**STAFF REPORT:** 08/14/2024 REGULAR MEETING  
**APPLICATION NUMBER:** HDC2024-00330  
**ADDRESS:** 14835 ROSEMONT  
**HISTORIC DISTRICT:** ROSEDALE PARK  
**APPLICANT/PROPERTY OWNERS:** CHAMEEKA AND JOHN DAVIS  
**DATE OF PROVISIONALLY COMPLETE APPLICATION:** 07/22/2024  
**DATE OF STAFF SITE VISIT:** 07/25/2024

**SCOPE:** REPLACE WOOD WINDOWS WITH VINYL WINDOWS

Figure 3, by Applicant: (east) front elevation showing proposed 2<sup>nd</sup> floor windows for replacement with vinyl.

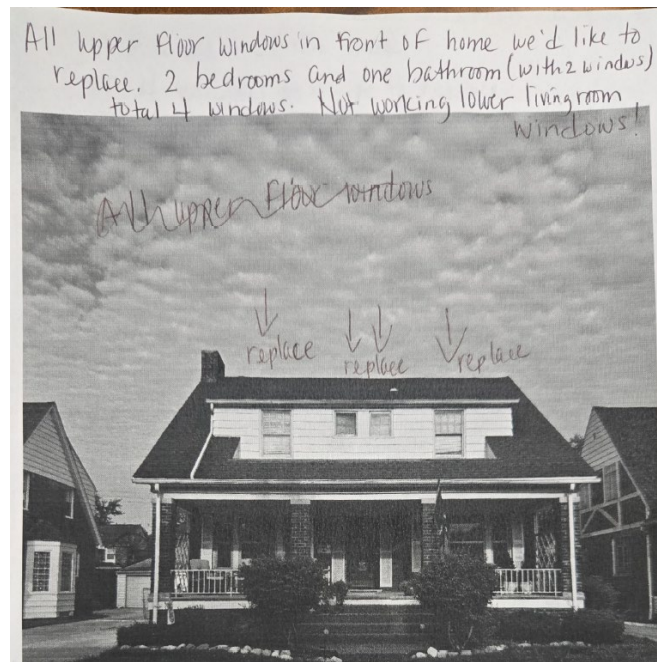
- The front upper story and the side elevation upper story windows are particularly visible from the public and are proposed for replacement with vinyl windows. Except for the rear kitchen windows, which are 1/1 double-hung, wood windows, the other windows have true divided-light mullions, most of which are 8/1 configuration. It is staff's opinion that these true divided-light, double-hung windows are distinctive character-defining features. Their loss would substantially detract from and destroy the historic appearance of the building. (See photos 1-3)

- In addition to a material change from wood to vinyl, the configuration and operation of the windows would also change. For example, the front elevation casement windows on the second floor are replaced with double hung windows and the light configuration changes from 8/1 to 4/2 grids between the glass according to the attached window order.

- Documentation establishing that the condition of the original wood windows is repairable and not beyond repair.
- The repair estimate states that “full restoration” is proposed and necessary. Staff question whether a lower level of intervention, short of “full restoration”, would retain the windows to a level of acceptable service, and be less costly.
- It is staff’s opinion that the removal of the original wood windows and replacement with white vinyl windows greatly alters the original *scale, design, and materiality* of the building’s fenestration and the new windows are incompatible and inappropriate for this historic property. Therefore, this work item does not meet the Secretary of the Interior's Standards for Rehabilitation and does not conform to the district’s Elements of Design.

- No documentation establishing that the original condition of the casement windows was beyond repair was submitted or available.
- A “full restoration” of the original windows may not be necessary to return to acceptable service.
- The replacement of the original wood windows with vinyl windows is not compatible with historic architecture in the house in that they:
  - destroy the distinctive, character-defining features of the original windows, particularly the true-divided lights detailing,
  - introduce a new design, and scale,
  - introduces a new material, vinyl, which is not historically appropriate material and does not conform to the District’s Elements of Design.

Staff therefore recommends that the Commission issue a Denial for the above work items, as it do not meet the Secretary of the Interior's Standards for Rehabilitation, specifically Standards:
